Project	IEEE 802.16 Broadband Wireless Access Working Group < http://ieee802.org/16 >
Title	Formats change for Figures 477 and 478
Date Submitted	2006-09-28
Source(s)	Peretz Feder - Lucent Technologies [mailto: pfeder@lucent.com]
Re:	
Abstract	This contribution proposes changes to Figures 477 and 478
Purpose	Adoption
Notice	This document has been prepared to assist IEEE 802.16. It is offered as a basis for discussion and is not binding on the contributing individual(s) or organization(s). The material in this document is subject to change in form and content after further study. The contributor(s) reserve(s) the right to add, amend or withdraw material contained herein.
Release	The contributor grants a free, irrevocable license to the IEEE to incorporate material contained in this contribution, and any modifications thereof, in the creation of an IEEE Standards publication; to copyright in the IEEE's name any IEEE Standards publication even though it may include portions of this contribution; and at the IEEE's sole discretion to permit others to reproduce in whole or in part the resulting IEEE Standards publication. The contributor also acknowledges and accepts that this contributi

Figure 477 – Context transfer primitives initiated by a serving BS

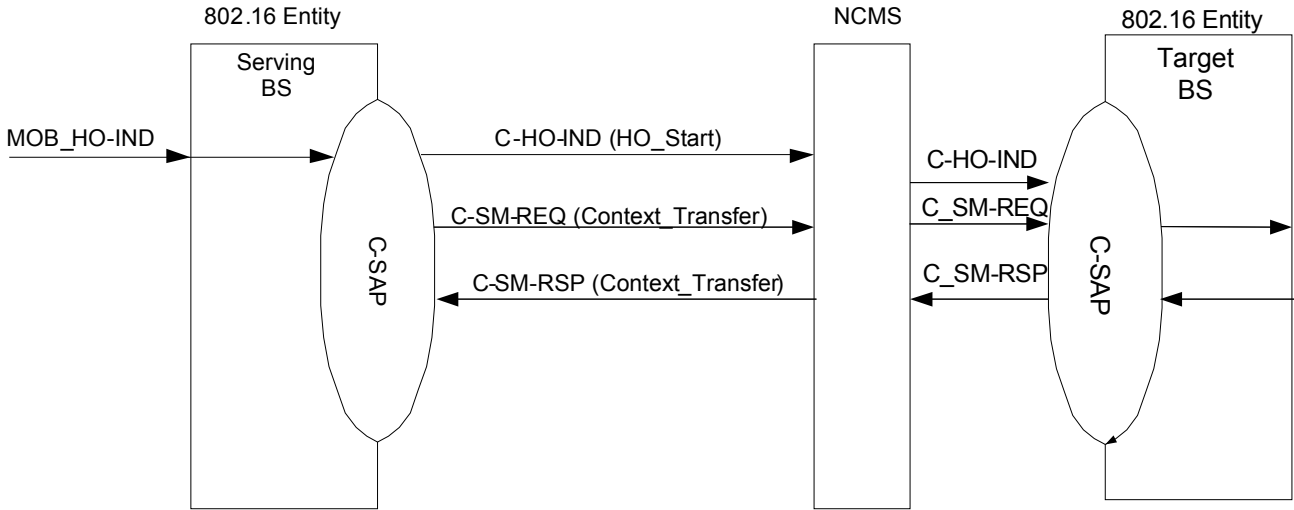
Figures 477 and 478 are hard to comprehend when combining call flows of serving and target BS within a single entity.

Split the serving and target BS and show call flow exchange through the NCMS

Split Serving BS and Target BS call flows per below:
